## PLANNING SERVICES

## STATEMENT OF CASE

### APPEAL SITE 12 Gloucester Gate, 12 & 13 Gloucester Gate Mews, NW1 4HG

**COUNCIL REFERENCE:** 2023/2155/P & 2023/2324/L

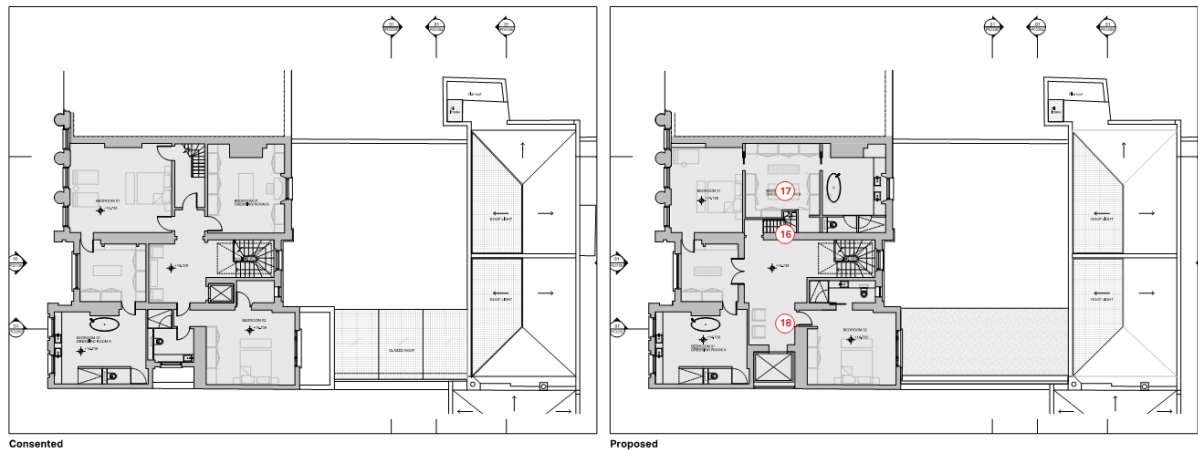
5.15. The relocation of the staircase was originally proposed when application ref 2017/2883/P was submitted where it was described as “Staircase to second floor to be carefully rebuilt in nearby location” (see image below). Historic

England (HE) and Council officers objected to this element of the proposal, and this part of the proposal was subsequently omitted prior to the determination and refusal of the application.

- 16 Staircase to second floor to be carefully rebuilt in nearby location. Hallway access adjusted to suit
- 17 Reconfigured Bedroom 01 layout

5.22. Relocation of bathroom door on first floor

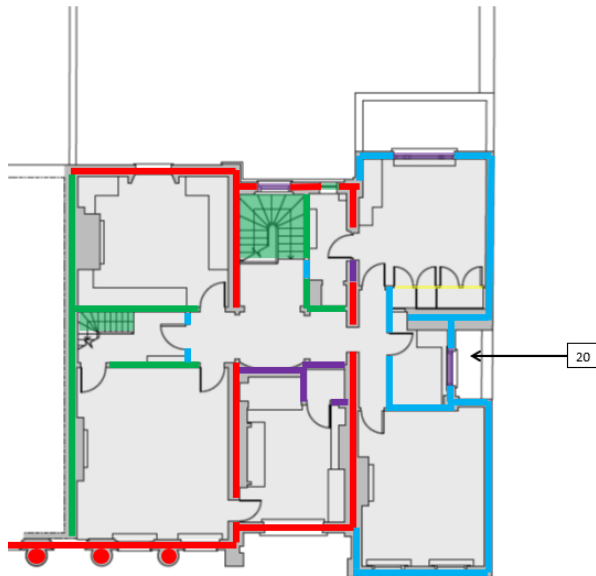
5.23. The appeal statement confirms that “the provision of this new doorway will result in some loss of historic fabric within the partition”.

Morphological Plan of the First Floor

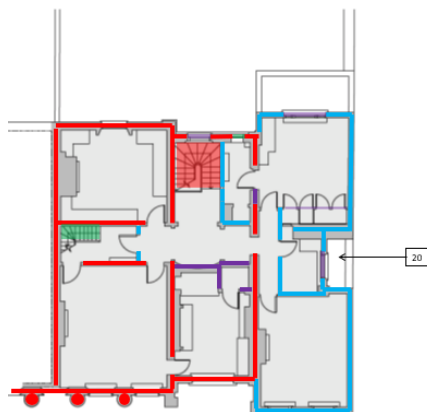
5.26. The wall where the bathroom door would be relocated is identified as being 'original fabric belonging to the Burton villa'. The Heritage Statement of Case dated June 2018 (submitted by the appellant for the previous appeal) also includes an assessment of significance alongside plans depicting significance.

Significance Plan of the First Floor

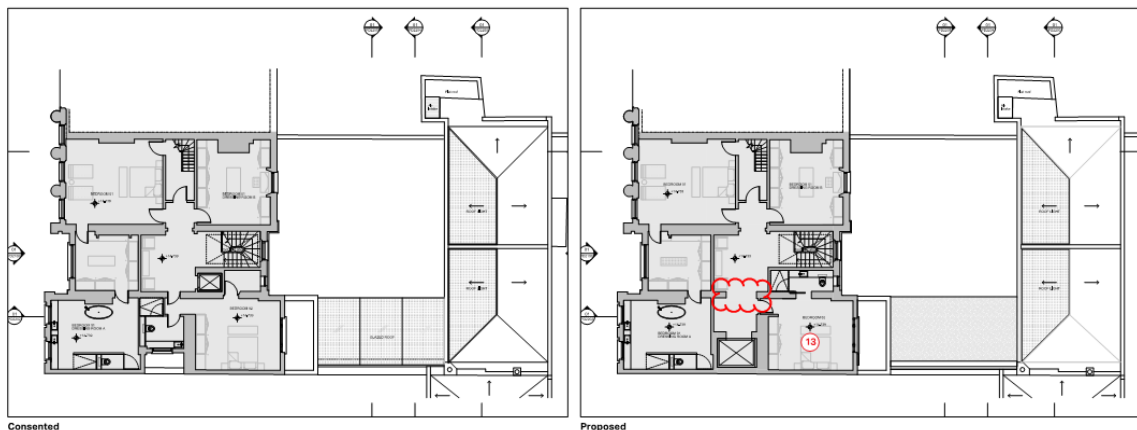
5.27. The proposed relocation of the bathroom door relates to the plan form of a room which is identified as being of high significance, being 'fundamental to the design concept of the building'. In the previous appeal the inspector also

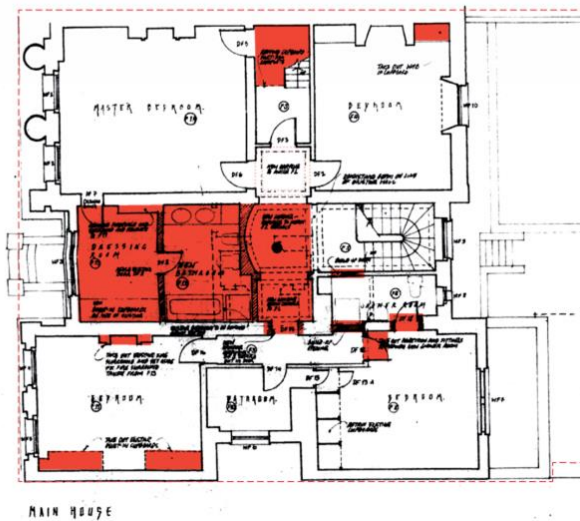
considered an alteration at first floor level of the Burton villa: the widening of the corridor by removing a section of wall in front of the lift entrance. This proposed alteration is shown below (highlighted by the red bubble). These plans are included in the appellant's Design and Access Statement Addendum S.73 Amendment (page 7) submitted for the 2017 appeal [Appendix 4]

5.28. Like the proposed bathroom door in the current application, the alteration would have involved the loss of historic fabric from the original Burton villa. The Council objected to this alteration and this was supported by the appeal inspector. The appeal decision [Appendix 5] included the following at paragraph 21.

5.29. *“On the first floor, it is proposed to widen the corridor by removing a section of wall in front of the lift entrance. This would represent a part of the historic masonry of the flank elevation of the original building, and it is therefore of intrinsic significance. In addition to the loss of fabric from the line of the original wall, this work would open up the hallway in area where the sense of enclosure is an important element of the character of the building. I accept that a relatively small section of wall would be removed. Nevertheless, the proposal would result*

*in both the loss of historic fabric and the erosion of the original plan form, and this harm would require clear justification.*

Fig. 3. First Floor as Existing, August 1929

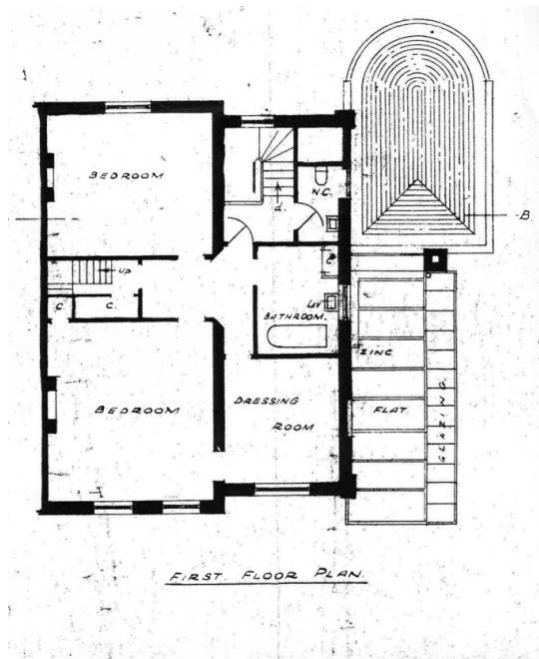
6.14. Whilst the return of the bathroom in the proposals to its current location will have a neutral effect, the moving of the door between the principal bedroom and the bathroom is likely to involve a structural intervention within a loadbearing wall, which would involve a loss of historic fabric and alter the historic plan form of the building. The existing door opening closer to the front façade of the house, which has been in position at least for the majority of the 20th and 21st centuries (see plan from 1929 below), should be retained.

- 6.15. The incorporation of ensuite WC and bathroom facilities in the principal rear room will require subdivision through the creation of a WC cubicle as well as the incorporation of plumbing with potential impacts from service runs on historic fabric. The subdivision of the room is discouraged due to the negative impacts on the plan form. The additional plumbing cannot be supported by officers in the absence of details of service runs and their impacts both on the interior and exterior of the listed building.
